Franklin Street & Valley Drive Stormwater Bypass Project Contract Change
Order Request No. 1

Reference: City of Dalton Stormwater Bypass Project
Pre Construction Changes

**WEST FRANKLIN STREET
BYPASS SYSTEM**

C-11

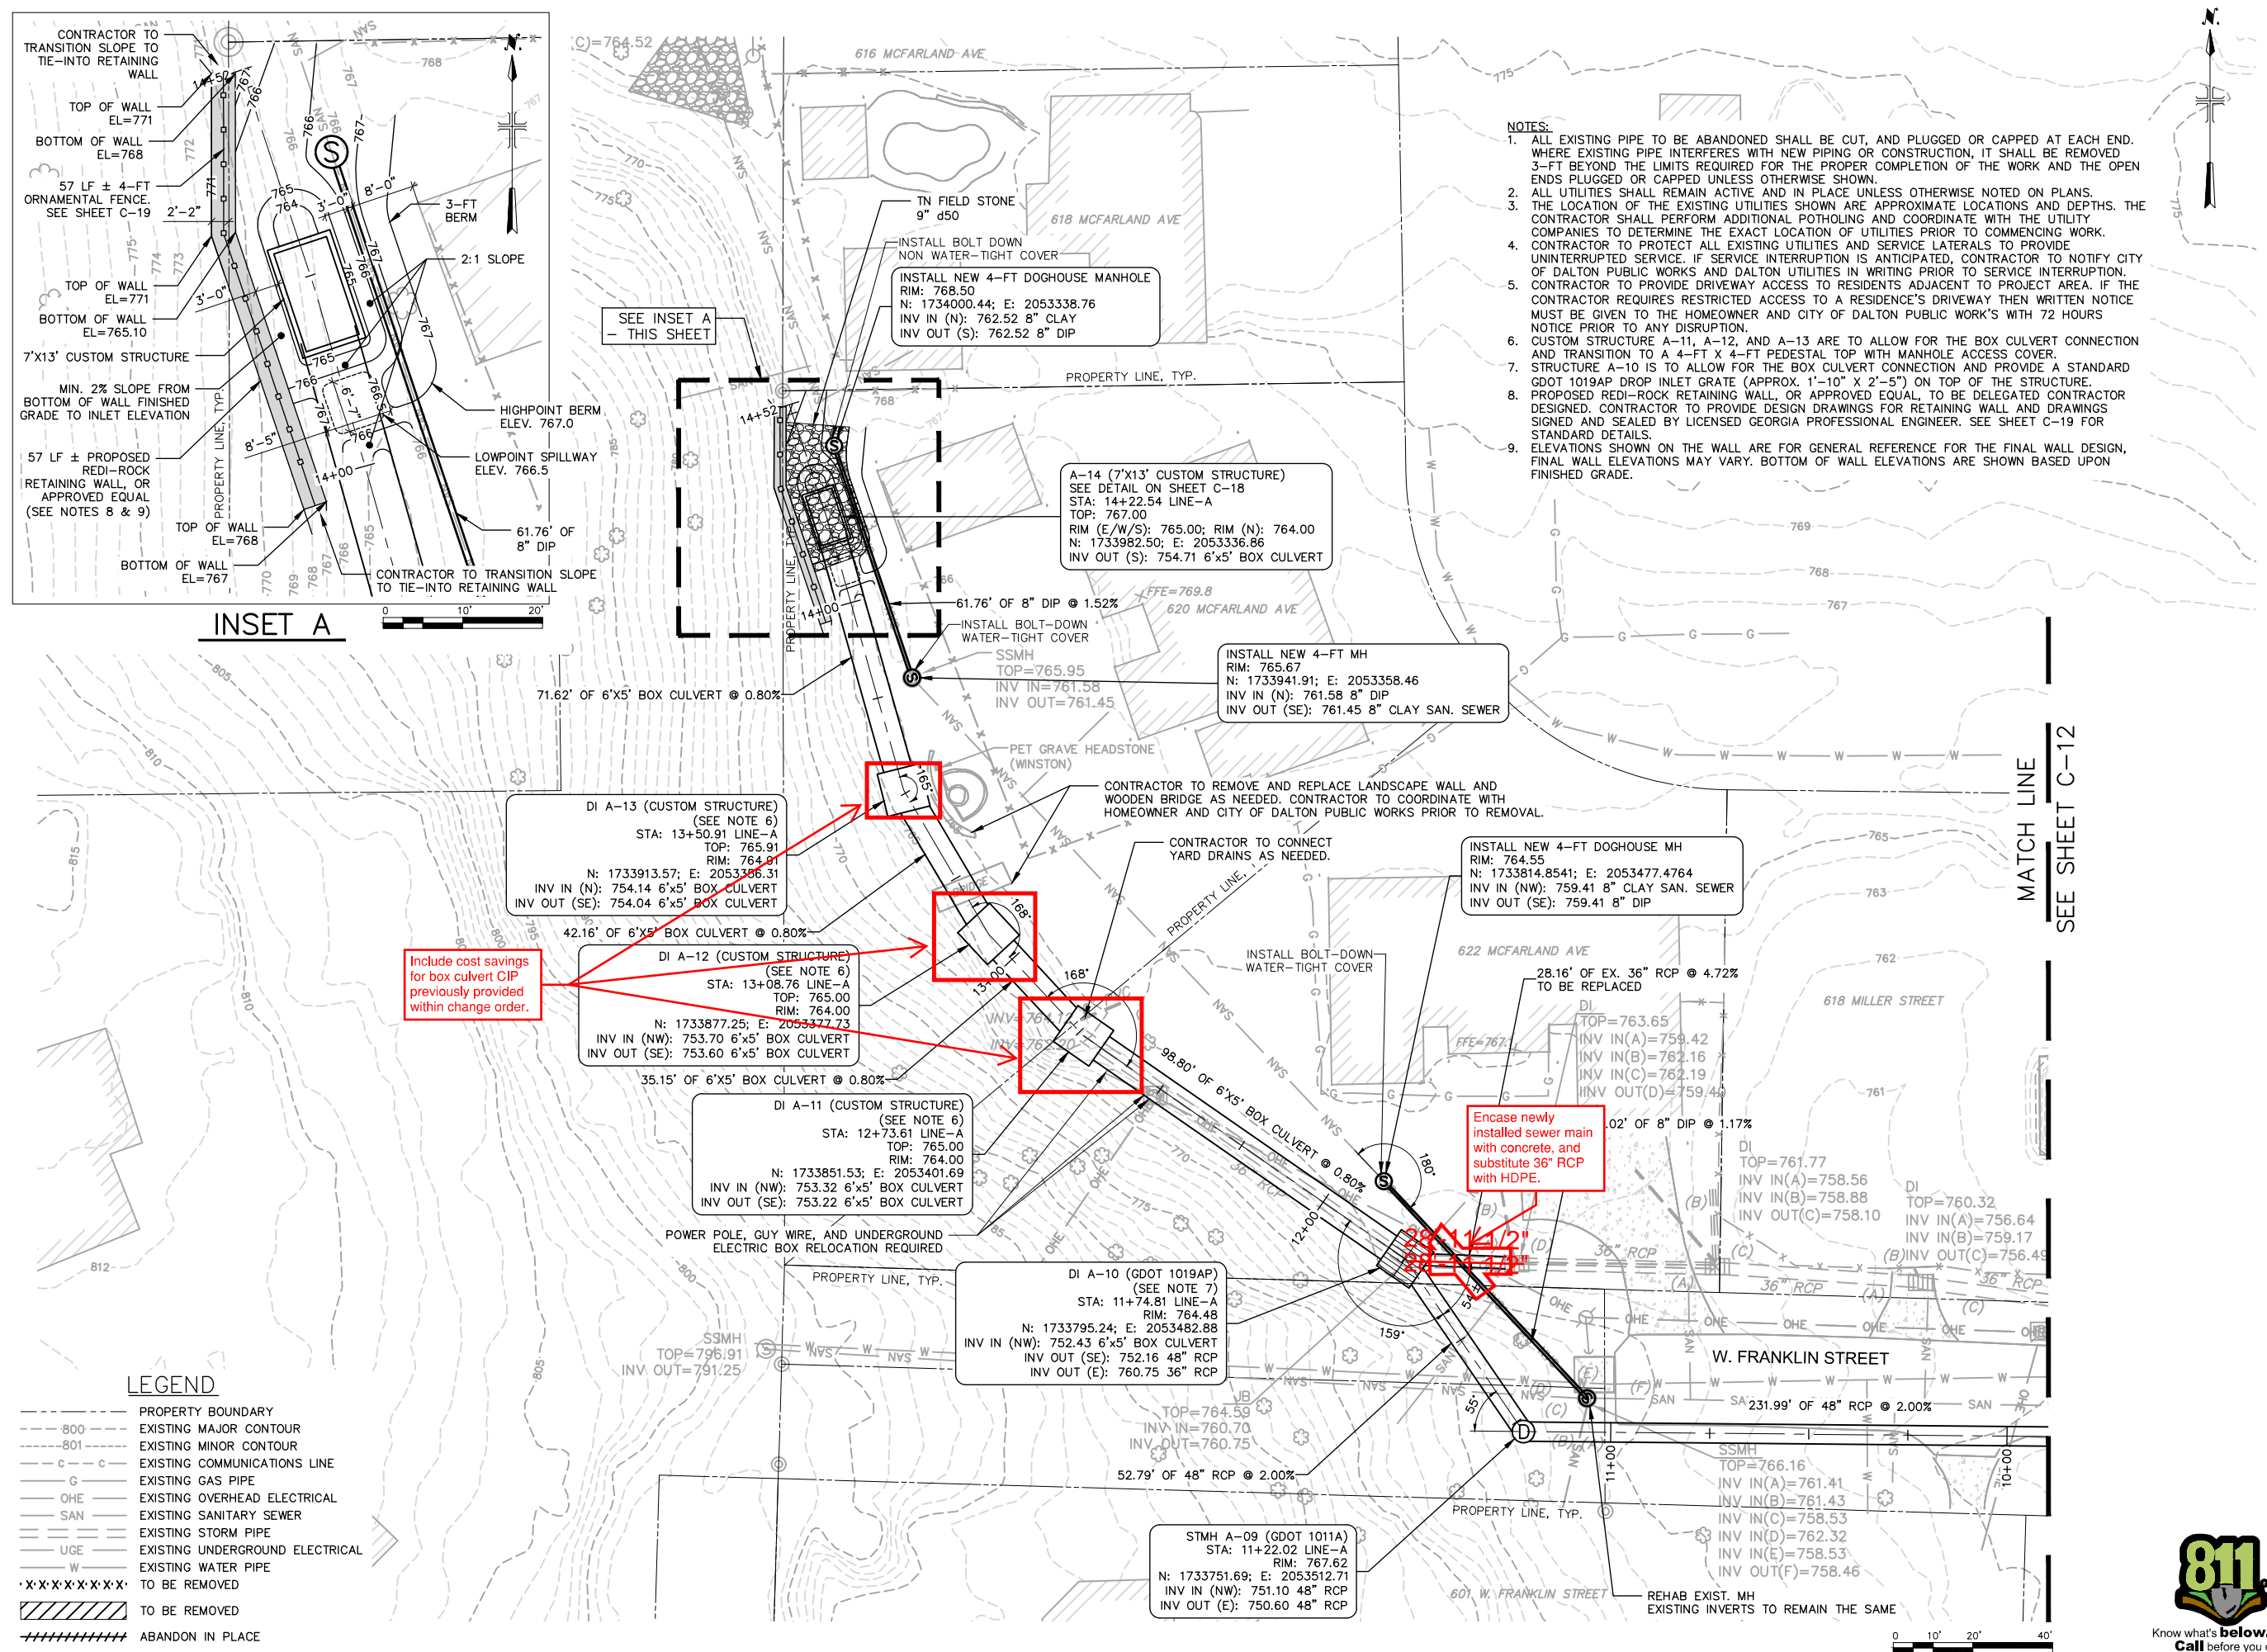
Prior to the start of the project several items were deleted or revised at the request of the Dalton Public Works department. These Include Deleting 6 Catch basins along Valley Dr. and West Franklin St., Revising Structures A-11,12,13, and changing the pipe between str. A-05 and HW B-01 from 18" class V RCP to 23"x14" class 4 elliptical RCP.

Along with the removal and revisions above DPW has also asked for the following to be added to the project. Tie 1 existing catch basin into str. A-08 with 40' of 25"x45" class 4 elliptical RCP and rebuild the existing catch basin. Replace the concrete driveway removed for this work and install 20' of concrete encasement for the new sewer line.
